REMARKS

Amendments to the Drawings

FIG.8

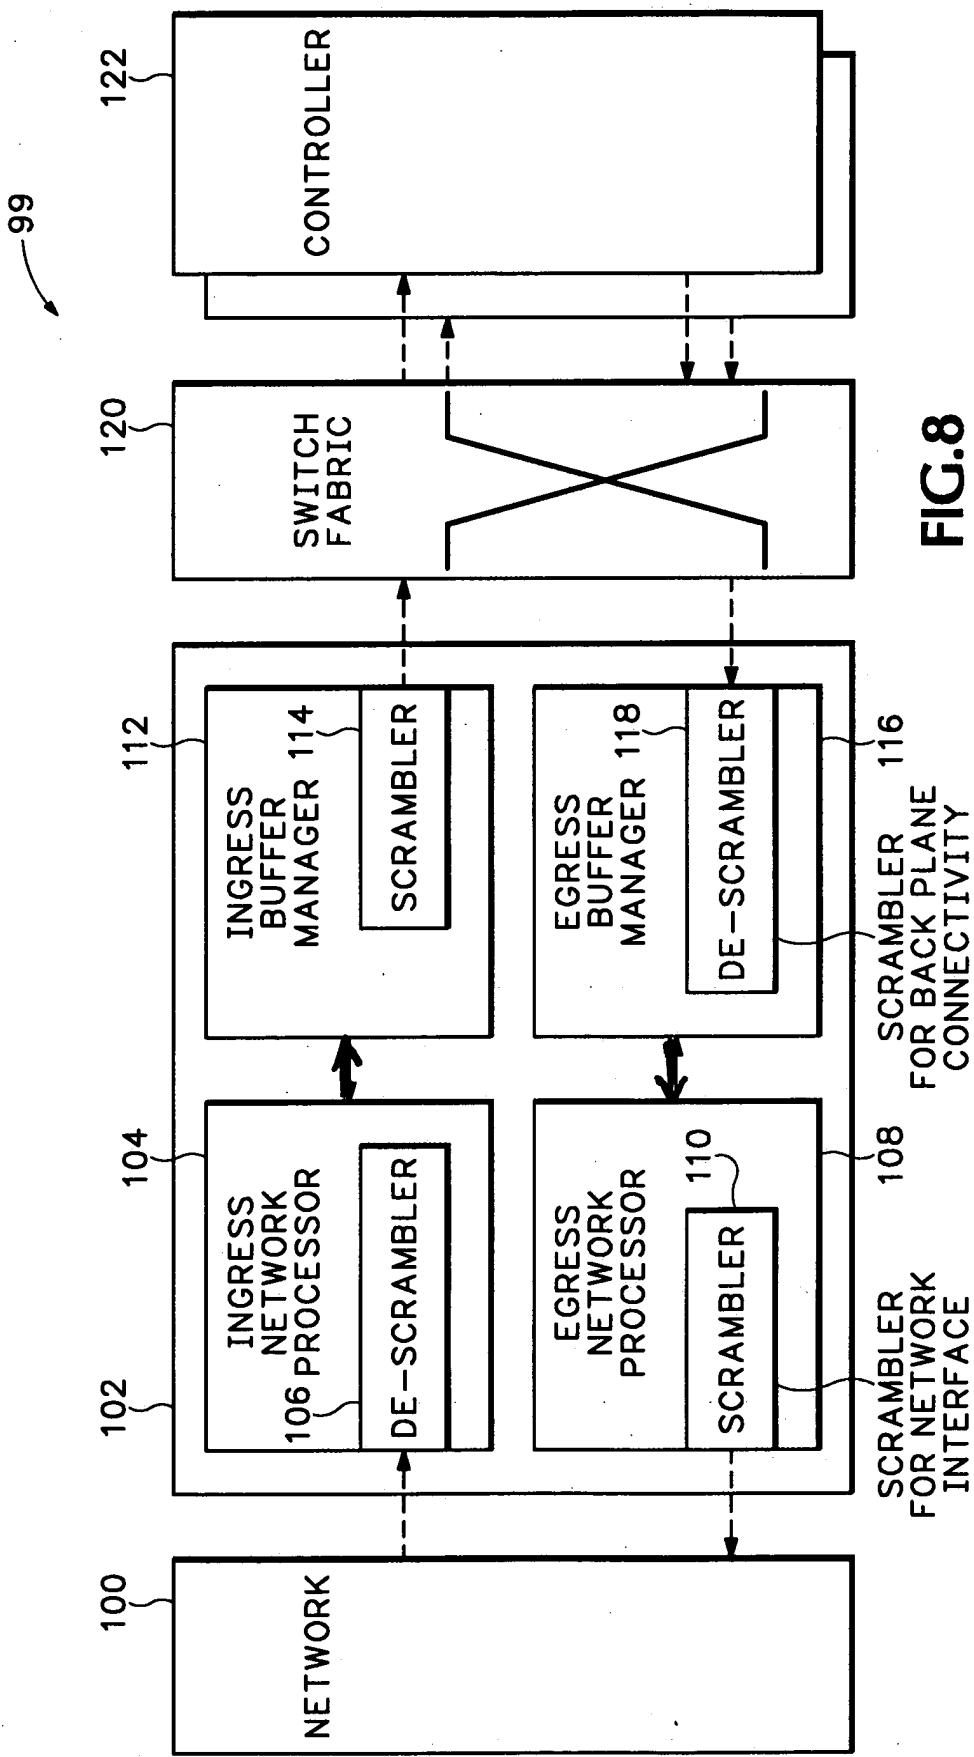
The Office Action indicates several potential informalities in the drawings. First, the Office Action indicates that Figure 4 contains a misspelled label “Scambler Polynomial.” Second, the Office Action indicates that Figure 8 contains incorrect flow directions between elements 104 and 112 and between elements 116 and 108. Applicants were able to locate the version of the drawings to which the Examiner was referring, and apologize for their confusion. Figures 4 and 8 have now been updated to address the informalities identified by the Examiner.

Replacement sheets for figures 4 and 8 are submitted herewith, along with marked up copies for the Examiner's approval, showing the changes made to figures 4 and 8.
